SSD 7317 MODIFICATION 3 – RESPONSE TO SUBMISSIONS

This Response to Submissions report (RTS) is submitted to the (the Department) in support of Modification 3 to amend State Significant Development (SSD) consent SSD – 7317 relating to the construction of a commercial campus at the Australian Technology Park, Eveleigh.

Figure 1 – North-eastern perspective of Building 3 and the service core – preferred option

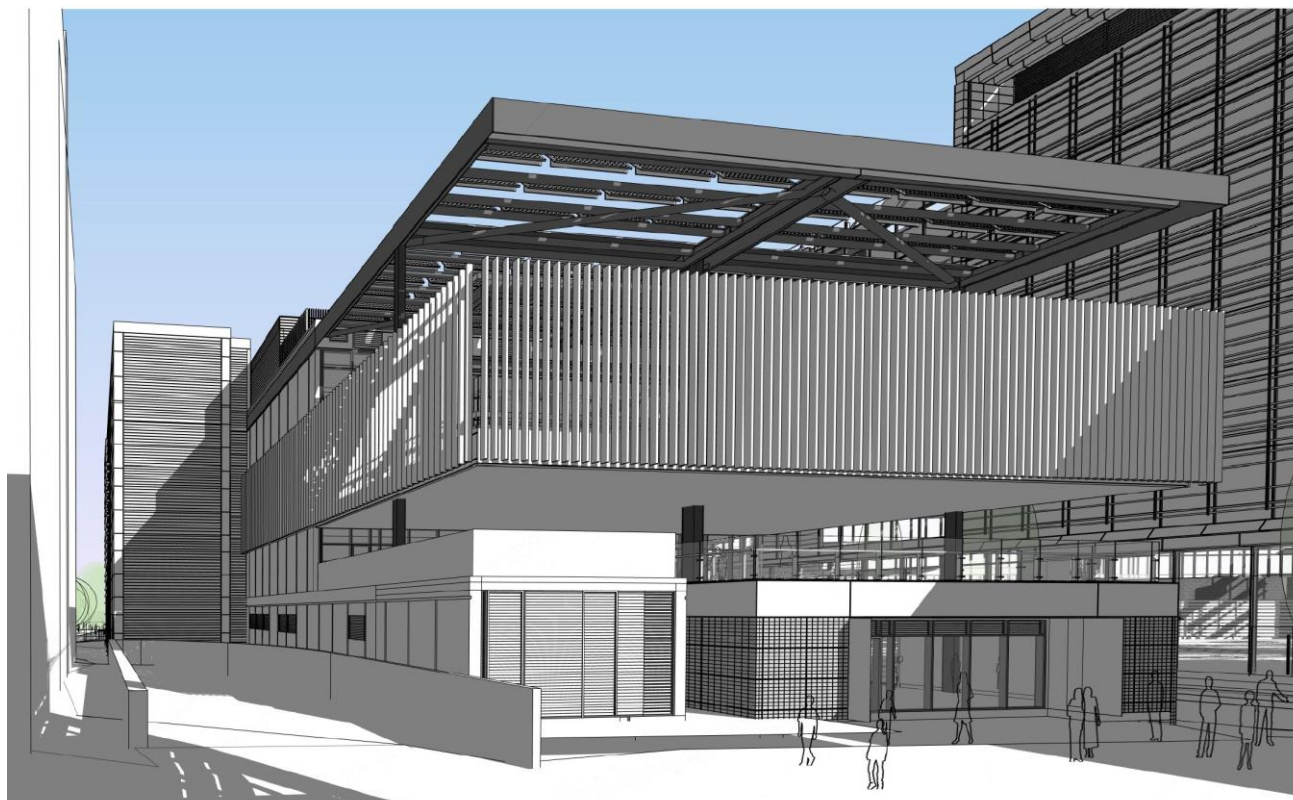
Provide options showing how the visual bulk and scale of the building can be articulated, with particular consideration given to the proposed changes to the western elevation (at levels 1 and 3) when viewed from the north and south

Both elevations also provide articulation through the setback applied to the services core where it joins the main building structure. This recess is shown on amended drawings 3300 and 3301 (**Attachment B**). Additionally, as shown in drawing 3907, there are two options provided that express this indentation in the services core (between the fire stair and main floor plate) – one being the current façade treatment and the other being a flat non-textured darker façade treatment. The former which continues the horizontal line design from the services core has been selected as the preferred design to provide a contrast between the vertical screening elements on Level 3. The second option is darker in colour finish to provide a more recessive aesthetic, providing visual separation between the core and the main floor plate. Furthermore, it is considered that a different façade treatment other than the two options proposed for the service core would be unnecessary given its considerable setback and its location adjacent to the vehicle ramp for the Biomedical

Building. Any further articulation is considered to conflict with the high level of articulation given to the north-eastern portion of Building 3 as shown in **Figure 1**.

Figure 6- Pedestrian pathways

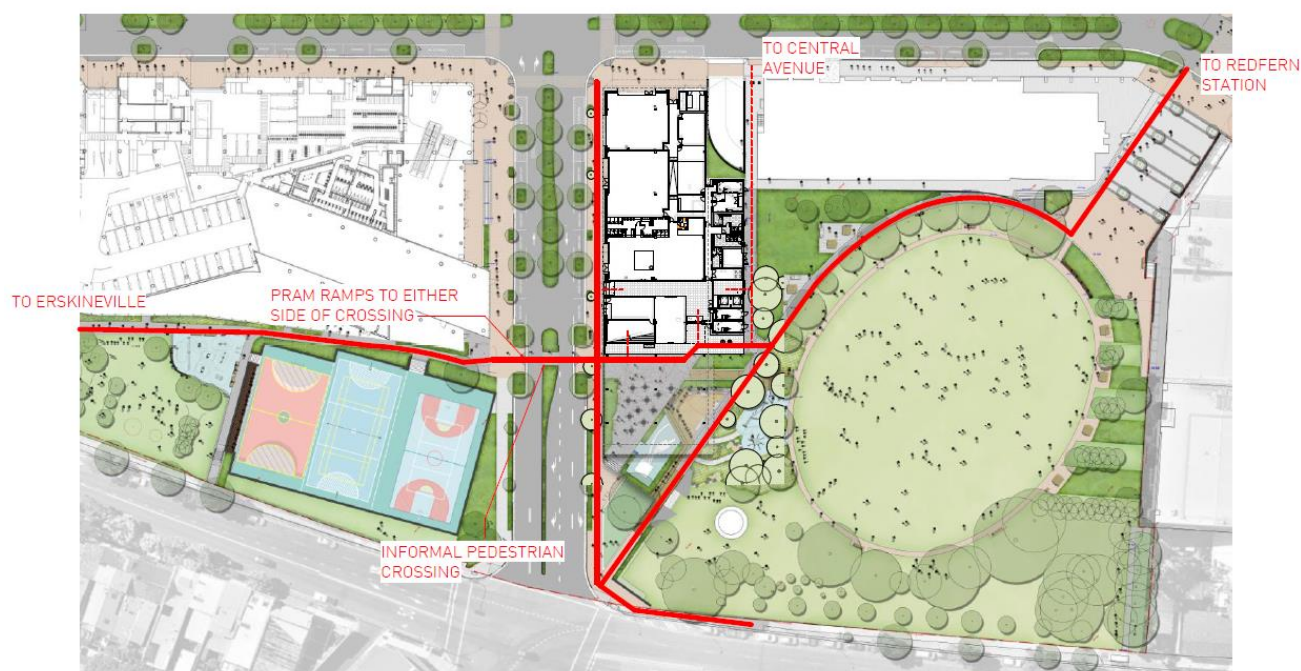
Further consider the design of the eastern and western elevations to improve activation and natural surveillance of the adjoining public domain (Vice Chancellor's Oval and Davy Street respectively) and in particular review the ground floor configuration to increase active uses fronting the Vice Chancellors Oval (having regard to the intent of Condition B3(b)2 of SSD 7317)

The eastern elevation also provides a significantly increased volume of glazing along the eastern frontage that improves the opportunities for natural surveillance over the Vice Chancellor's Oval and as shown on the Plan (DA_3301) attached, a doorway is proposed to be provided at ground floor level leading from the lift lobby towards the BBQ area adjacent to the Vice Chancellor's Oval to provide a second through-site link and direct access to the pathway that runs northwards to Central Avenue. Additionally, pram ramps and crossings will be provided on Davy Street (**Figure 6**).

Figure 7- Permeability plan

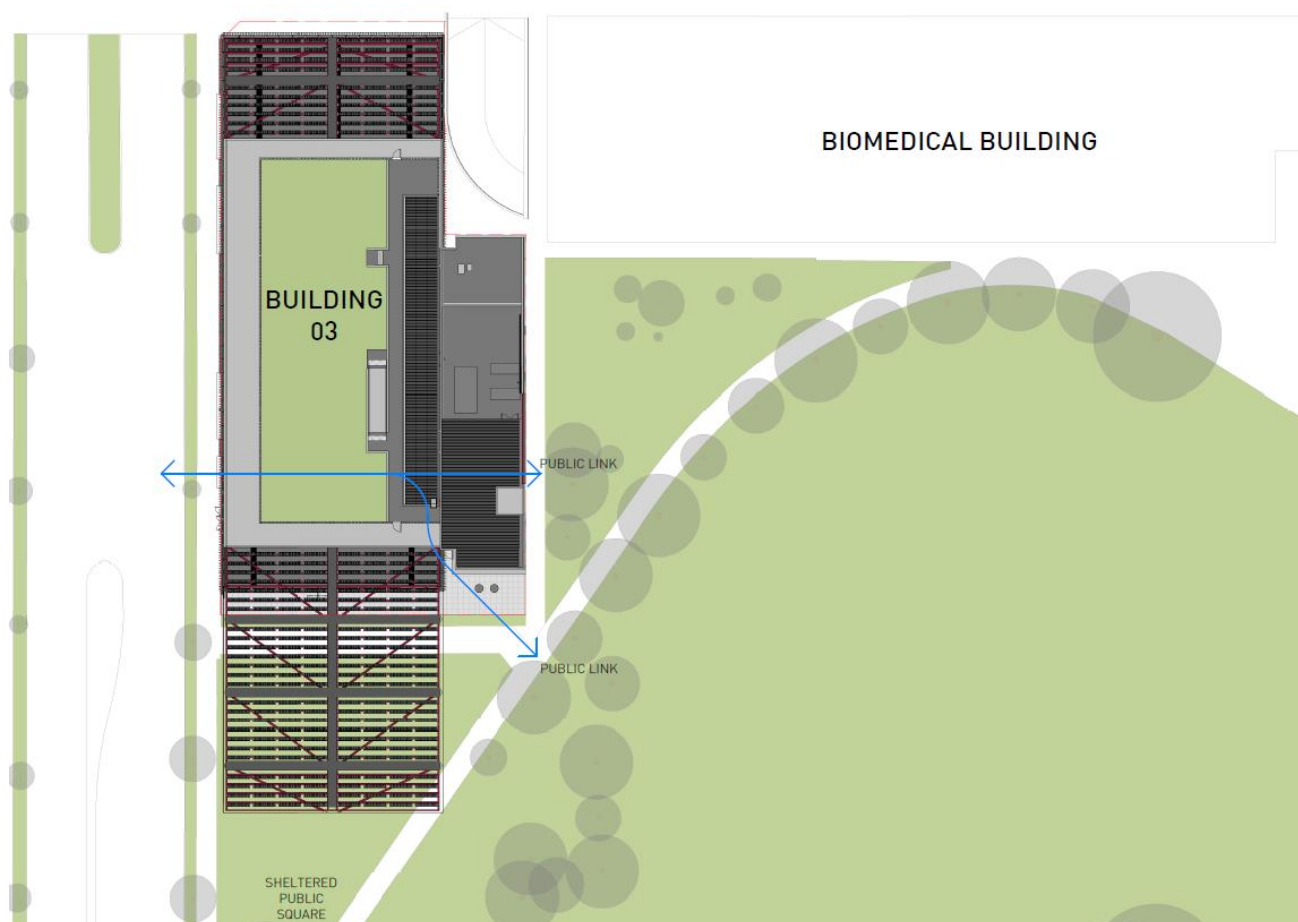
Provide further justification and analysis showing how the relocated pedestrian link will improve permeability, legibility and accessibility between Davy Road and the Vice Chancellor's Oval through the Building 3 site.

The proposed pedestrian link is coordinated with the precinct pedestrian study and approved public domain design. When designing the wider precinct, a pedestrian study was undertaken to map the flow of pedestrians through the site (**Figure 6**). The buildings and public domain have been designed to respond to this. The location of the pedestrian link in the approved design offers a poor outcome in response to the pedestrian study and is not supported by the public domain design intent to provide a quiet and more passive open area to the north-west of the Vice Chancellor's Oval.

The reconfigured design draws from Mirvac's overall vision to maximise activation and connectivity along the south-east elevation which is achieved in the following ways:

The reconfigured through-link ensures wayfinding through the Building 3 area is clearly defined and accessible.
